Spreeukloof Wind Energy Facility, Eastern Cape Province

Motivation for amendment of Environmental
Authorisation

DEA Ref.: 12/12/20/1778/5

July 2021

Figure 2.3: Wind farm layout showing the proposed amendment (2021) layout with reduced turbine number and revised turbine specifications overlain onto identified sensitivities as part of the amendment process (A3 Map included in Appendix I).

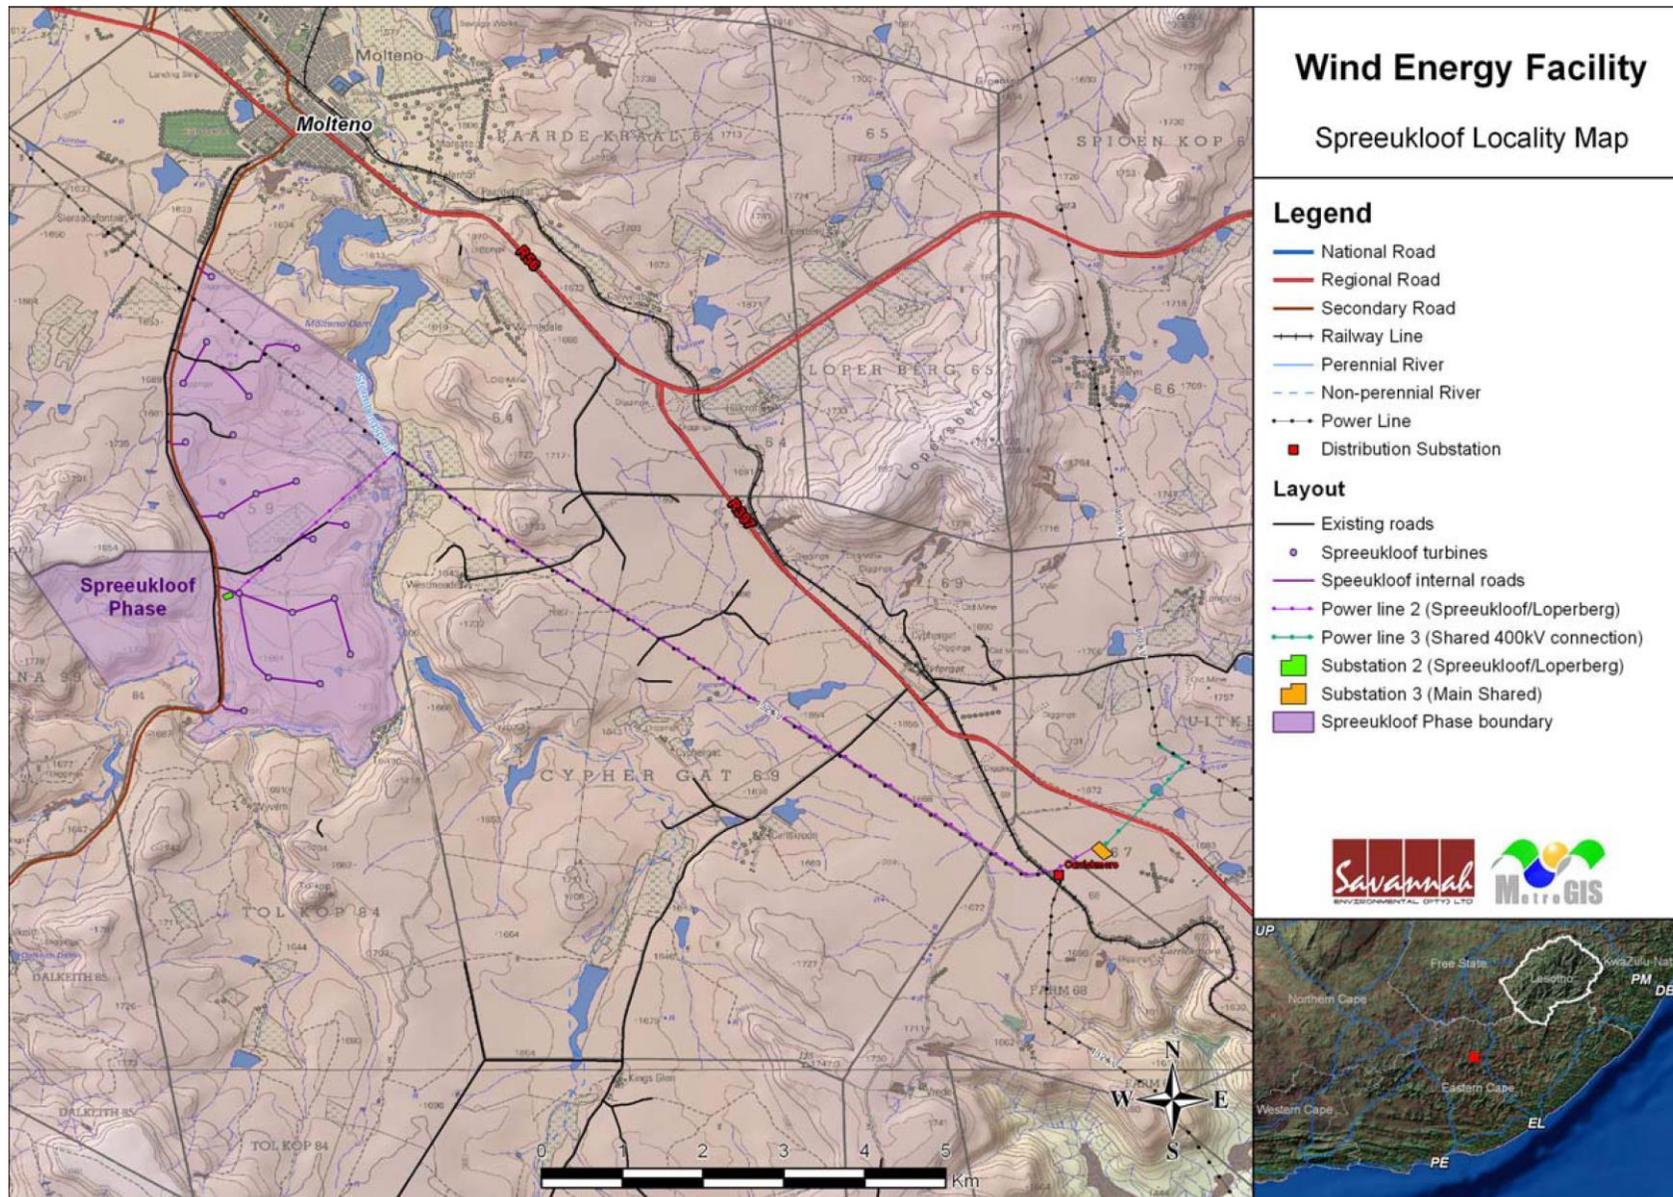
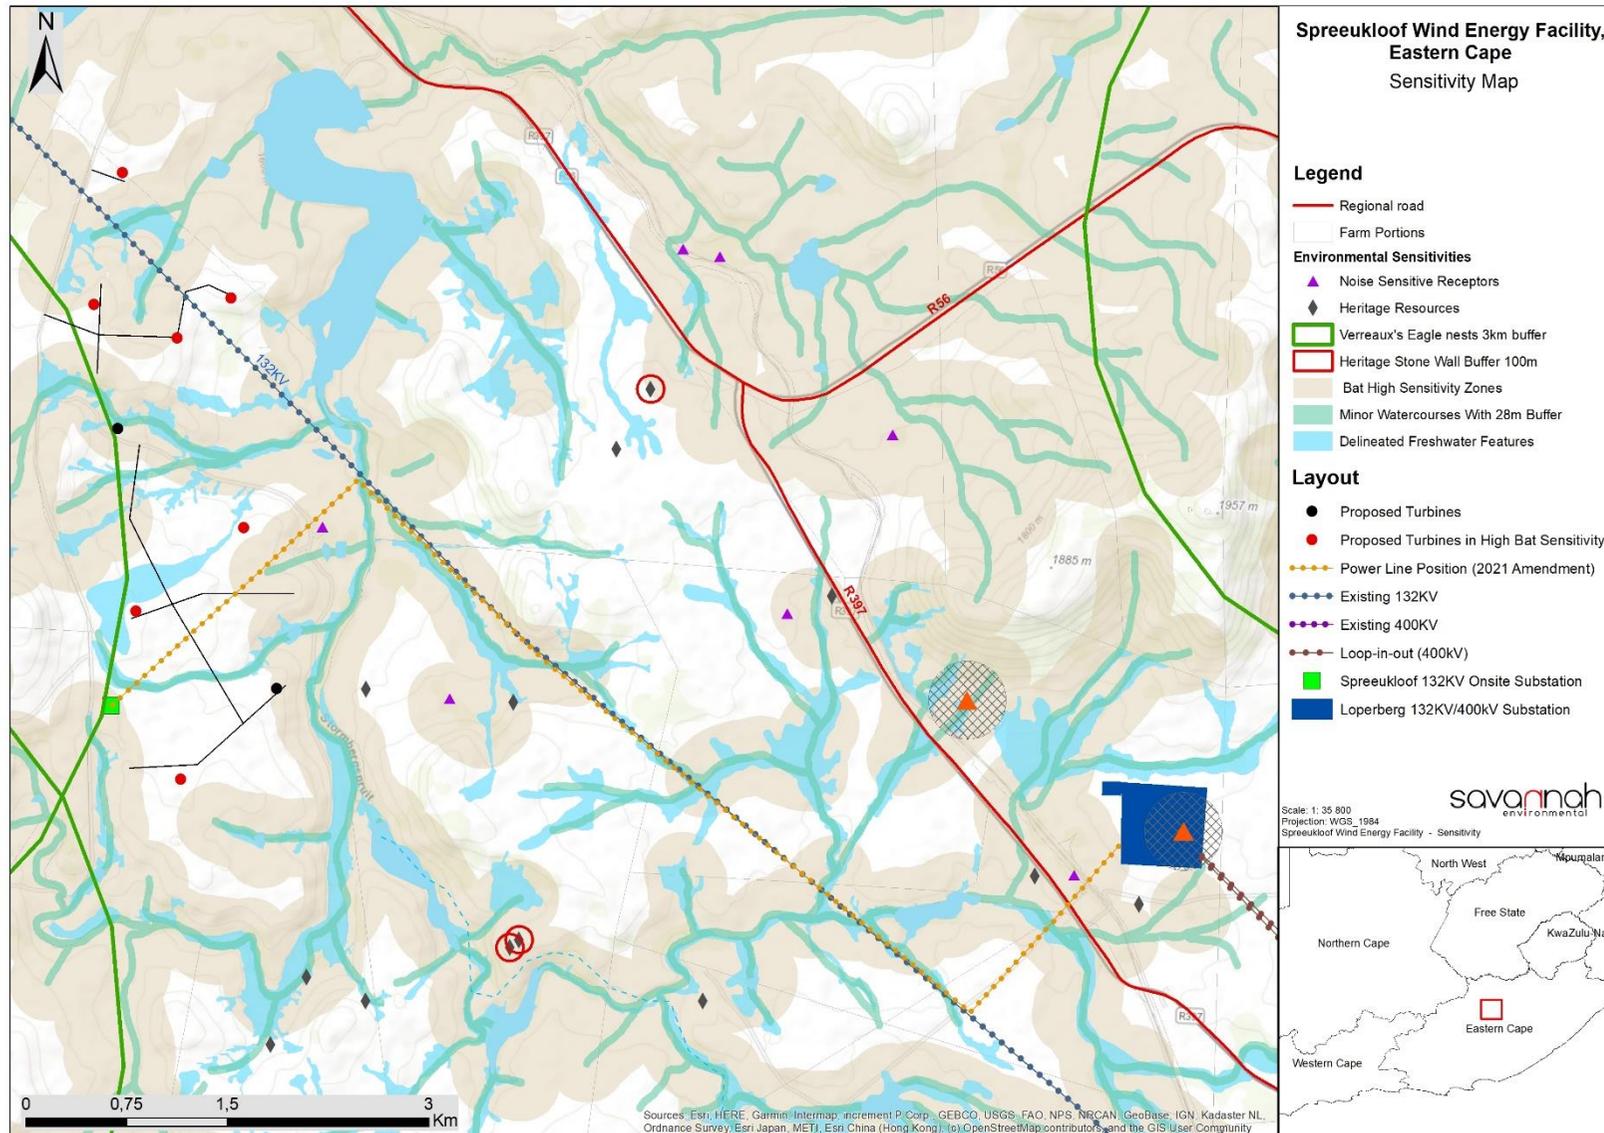
The number of wind turbines are proposed to be decreased from the currently authorised 21 turbines, to 'up to 12' turbines. It is therefore requested that the project description in the EIA be amended to include the revised number of turbines.

A revised layout is provided in **Figure 2.1**. It must be noted that this layout is not submitted for approval at this time. The final layout will be submitted following final design prior to construction as per the requirements of Condition 28 of the EA.

A layout indicating the 12 turbine positions is provided in **Figure 2.3**. It must be noted that this amendment request is not for final approval of the facility layout as per the facility EA conditions. This will be undertaken following the detailed design for the project in accordance with the requirements of Condition 28 of the EA (dated 2 November 2012).

**Figure 5.1: Indicative diagram of the original and proposed rotor swept areas. Not to scale.
Change in overall risk window presented by facility**

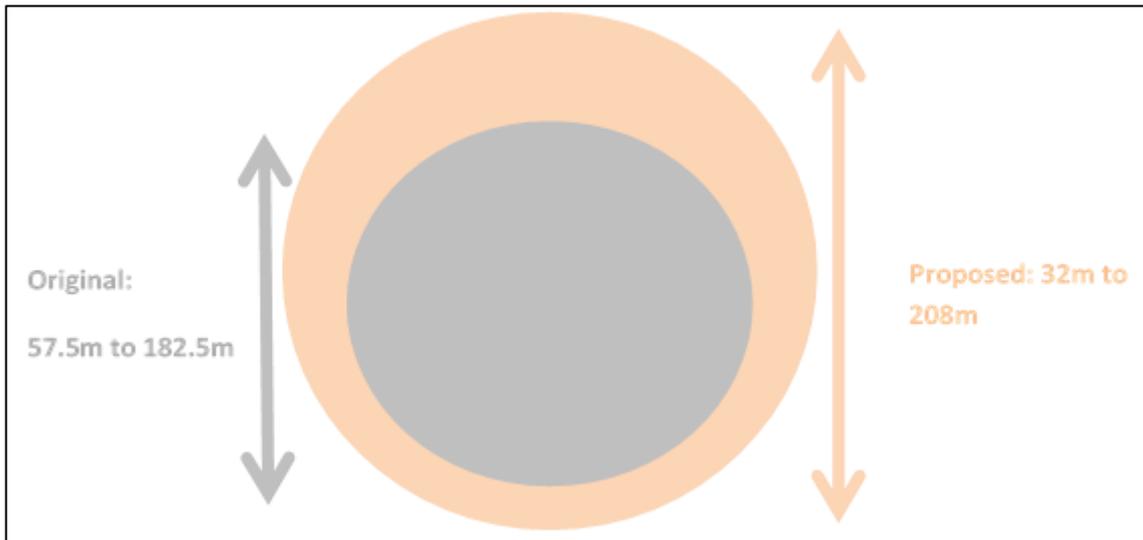
Two aspects of the change in turbine model are relevant to assessing bird turbine collision risk: the change in height above ground at which the rotor will be and the change in overall size of rotor. The change in the number of turbines and facility layout affects the risk associated with the project as a result of the change in turbine specifications.

For the purposes of this analysis, the avifaunal specialist assumed the largest turbine model within the range applied for, as a worst-case scenario. The original authorised model would have had a rotor swept area from 57.5m to 182.5m above ground. The new proposed turbine would have a rotor swept area of 32m to 208m above ground if the maximum hub height is used. **Figure 5.1** below shows the two rotor swept area scenarios. The lower tip of the proposed new rotor drops by 15.5m. This is a slight disadvantage for avifauna as much of the typical bird flight is in the first 20-40m above the ground. Dropping the blade tip therefore slightly increases collision risk. Whichever hub height is used, the lower blade tip is not lowered below 30m above ground.

The turbine model authorised originally had a maximum 125m rotor diameter and therefore presented a collision risk window of 12 271.85m² per turbine. The proposed change to a maximum 176m rotor diameter will increase the collision risk window presented by each turbine to 24 328.49m². This almost doubles the per-turbine collision risk window. The number of proposed turbines has however reduced from 21 to 12. The overall wind farm collision risk window would therefore increase from 257 708.85m² (21 x 12 271.85m²) to 291 941.88 (12 x 24 328.49m²). This represents an overall increase of 13.2%. This is also added to by the lower blade lowering.

Figure 5.2: Bat sensitivity map for the amended scenario.

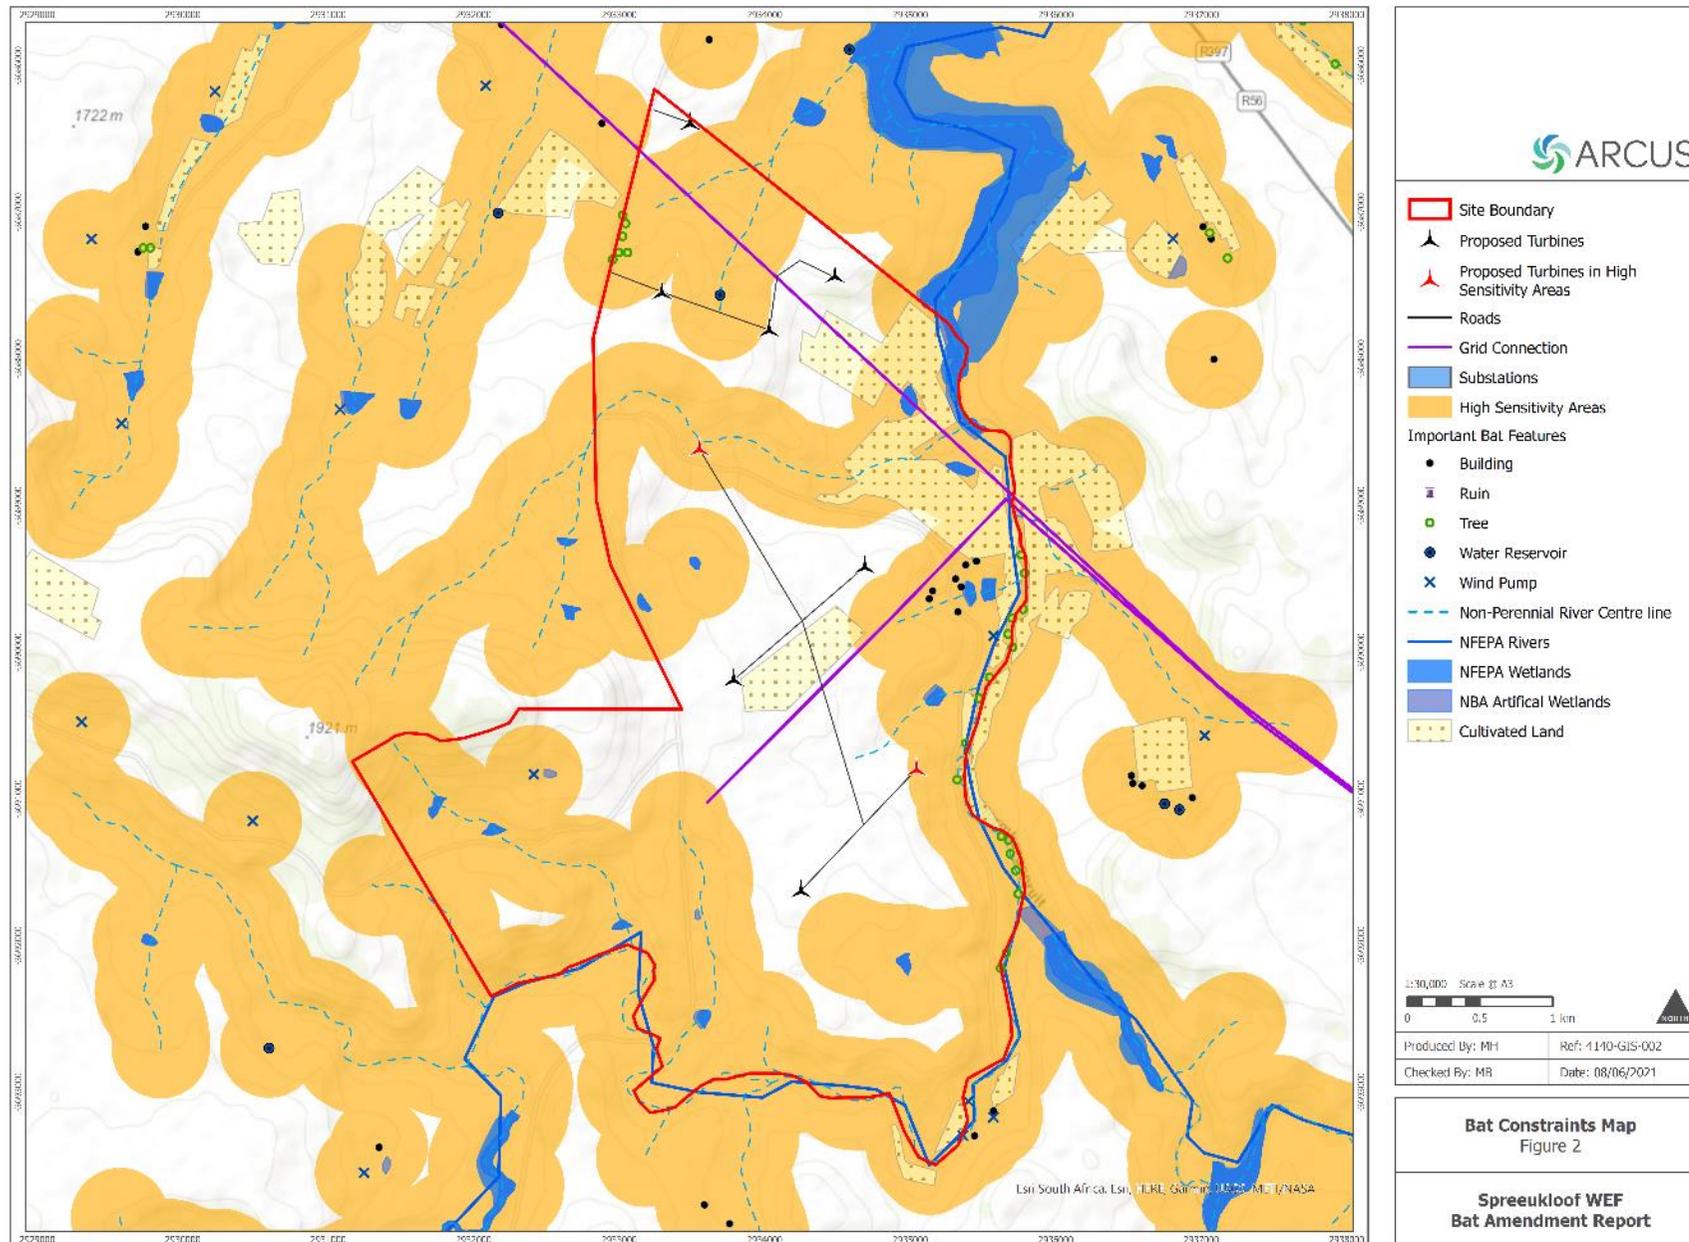
The sensitivity map determined for the amendment by the bat specialist is provided below (refer **Figure 5.2**), indicating the delineation of sensitive areas following fieldwork and assessment by the specialist.

The increase in the rotor diameter will be negative for high flying bats species, particularly to free-tailed bats, which are present on site and have fatally collided with turbines in the Eastern Cape. This is because taller turbines are predicted to kill more bats. However, unpublished data from numerous wind farms in South Africa show bat activity generally decreases with height and it is unlikely that the upper tip height increase would result in a significant difference in fatality for this group of bats. Given the lower activity recorded at height, this would not change the previous assessments findings. However, the decrease in the lower tip

height will be negative for low-flying bats as the blade swept area will encroach into their lower flight zone, potentially increasing the likelihood of collisions.

- » All currently proposed mitigation measures proposed in the Spreeukloof WEF EMPr / EA must be adhered to. This includes adhering to the updated sensitivity map (**Figure 5.2**) which will require repositioning 2 turbines that intrude into high sensitivity buffers. These buffers are regarded as high sensitivity areas for turbine components only, and other infrastructure (roads, cables etc) are permissible. These areas include 500m around all cliff lines and 200m around all other important bat features and potential roosts. Should important features, including wind pumps and water reservoirs be removed or covered, these buffers would not apply and can be removed.

Figure 5.4: Heritage resources map of the amendment scenario layout (2021), including recommended specialist buffer areas.

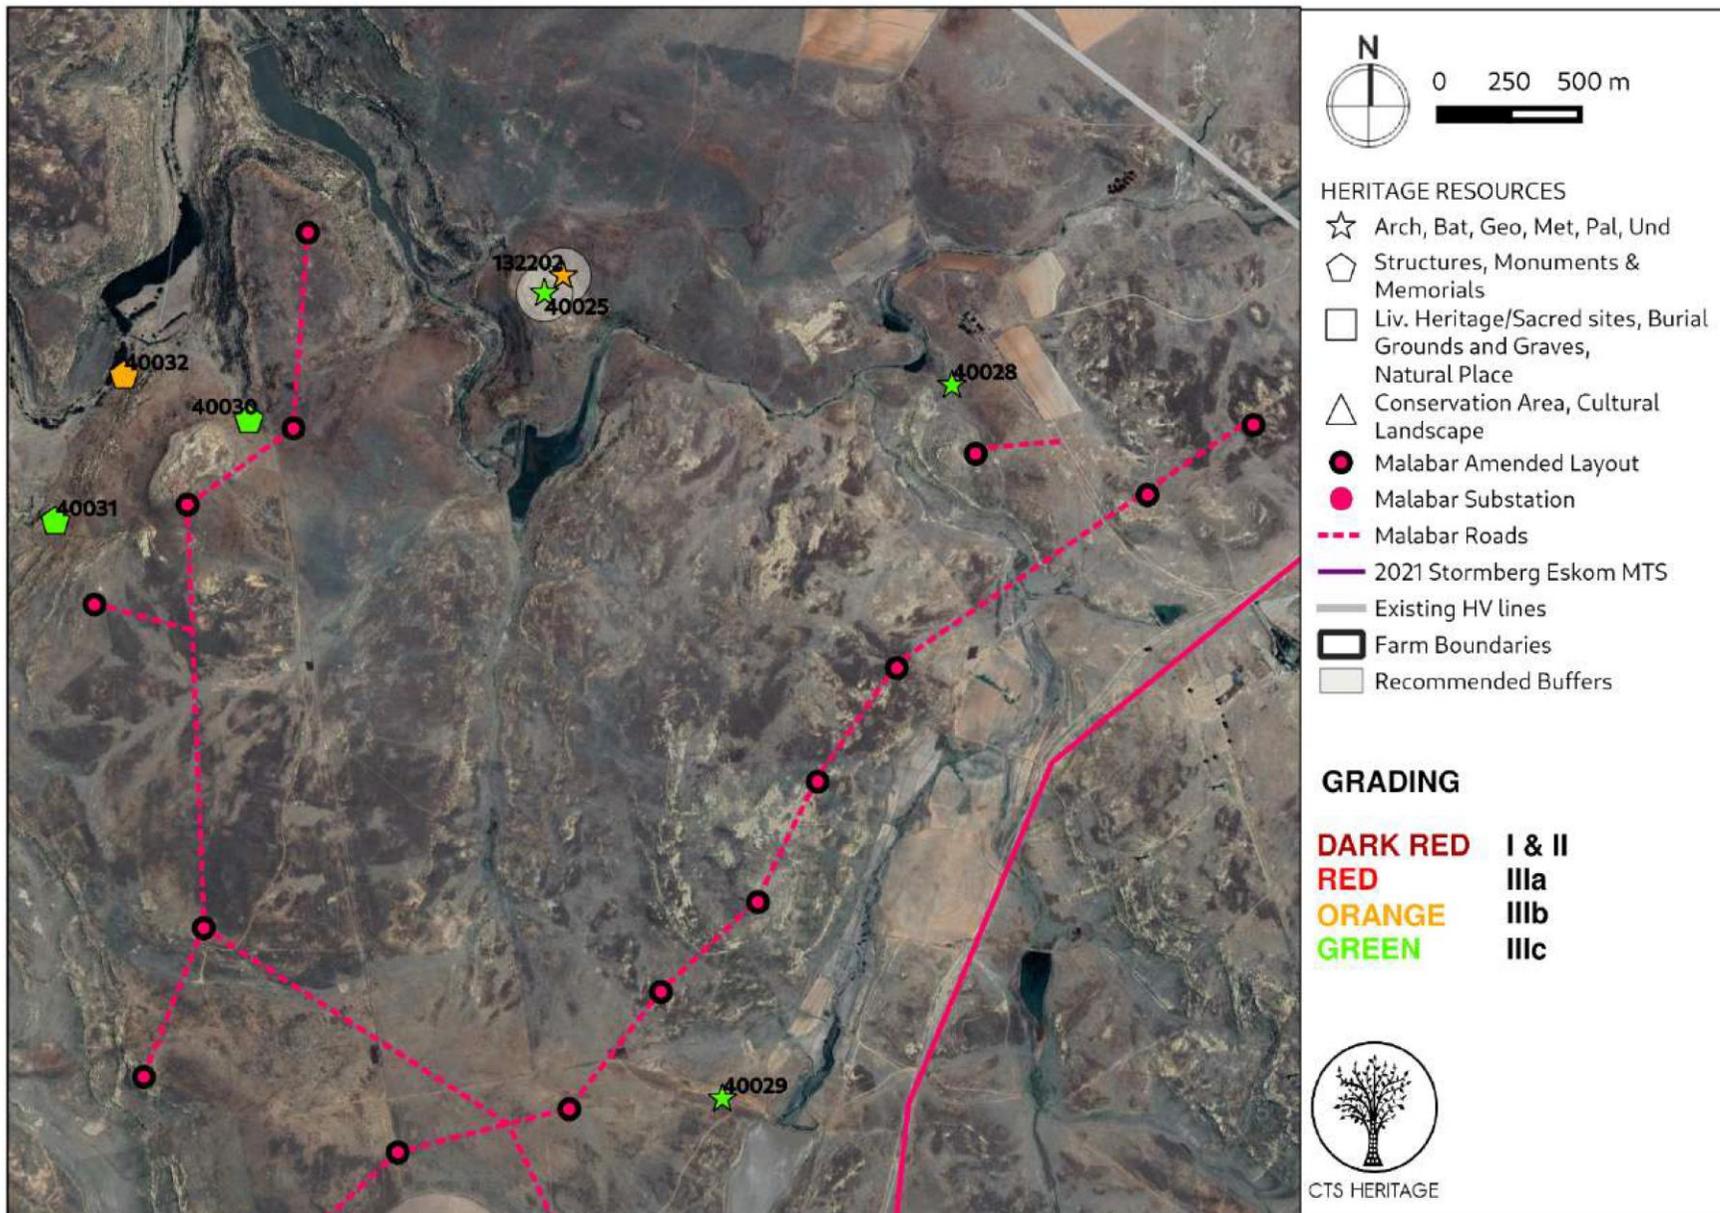
As part of the original process followed for the Dorper Wind Energy Project and the authorised layout for Spreeukloof WEF, Binneman, Booth and Higgitt (2010) conducted an archaeological impact assessment. According to Binneman et al. (2010), "Surface scatters of Middle Stone Age (MSA) stone artefacts were observed over most of the area surveyed. These occur between the surface and approximately 50 cm below the current surface level. Later Stone Age (LSA) stone artefacts were also observed as surface scatters, but mainly occurred in density around the koppies and rocky outcrops. Stone walling and remains thereof occur on the landscape, mainly as dam walls, but also as remaining foundations of buildings. Stone walling was also observed in some rock shelters on the koppies/rocky outcrops, which may either have been used as stock kraals/pens and to provide shelter from the wind as occupation areas. Historical buildings and abandoned farmhouses with outside rubbish dumping areas containing stoneware and porcelain ceramics as well as glass, iron and copper also occur within the proposed area for development. Graveyards and informal burials were also observed within the proposed area, most of the burials are deemed to be older than 60 years. No other associated archaeological materials were observed with the stone artefact scatters, and it is unlikely that the stone artefacts would be in primary context. No sites containing any depth of deposit or other archaeological material associated with the stone tool artefacts and archaeological material were observed within the proposed area for development." Refer to **Figure 5.3** for heritage resources map previously identified within the study area, with SAHRIS Site IDs. The amendment layout showing heritage resources with recommended buffer zones is further shown in **Figure 5.4**.
